Product Change Notification

Change Notification #: **106752 - 00**

Change Title: **Intel 82559 10/100 Mbps Fast Ethernet Controllers, 82559ER Integrated 10BASE-T/100BASE-TX and 82559C Fast Ethernet Controllers**

Moisture Sensitive Label Change

Static Bag Moisture Sensitive Label

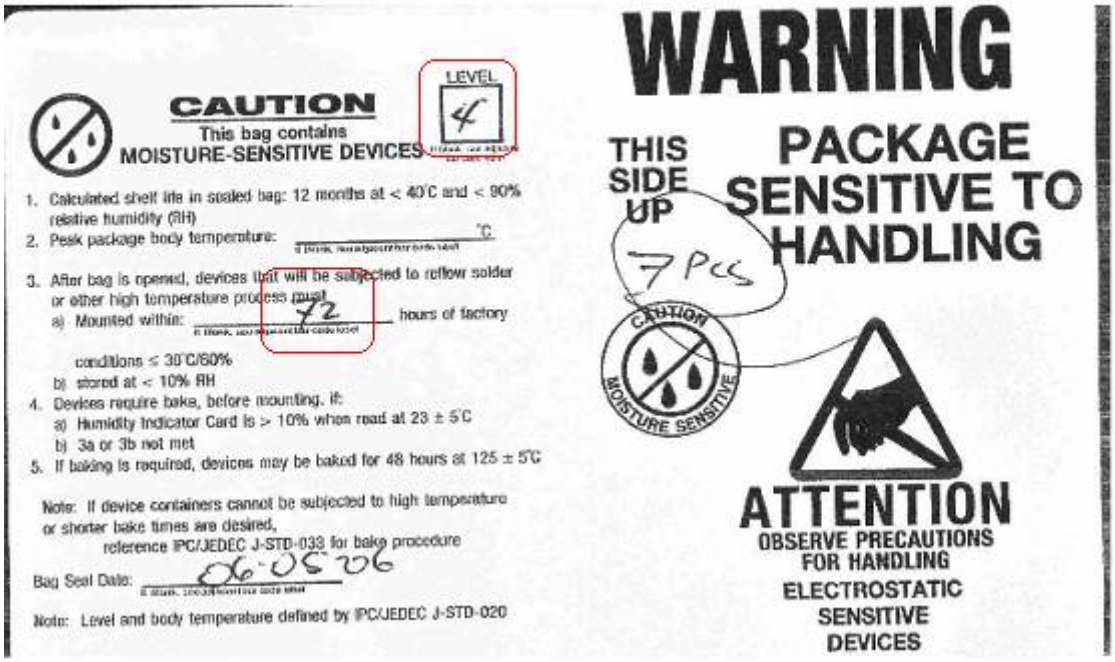
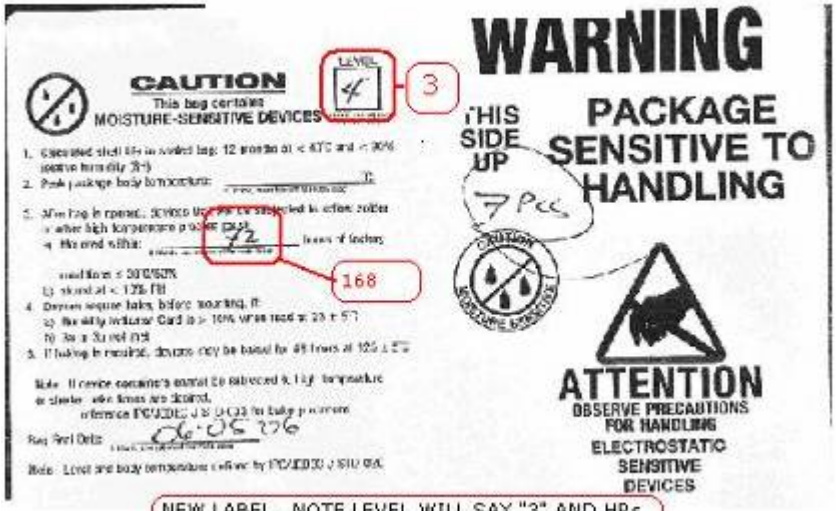
The Moisture Sensitive Label (MSL), located on the outside of the static bag, will now be marked with a L3, it was previously marked as a L4. L3 allows for 168 hours of open floor life, in comparison to L4 which allows for 72 hours of open floor life. Open floor life is the amount of time the silicon static bag can be left open before the moisture level reaches a level that would require re-baking and resealing.

BEFORE CHANGE. AREAS THAT WILL CHANGE ARE CIRCLED IN RED

AFTER CHANGE. LEVEL will be "3" and HRS will be "168"

NEW LABEL. NOTE LEVEL WILL SAY "3" AND HRs WILL SAY 168
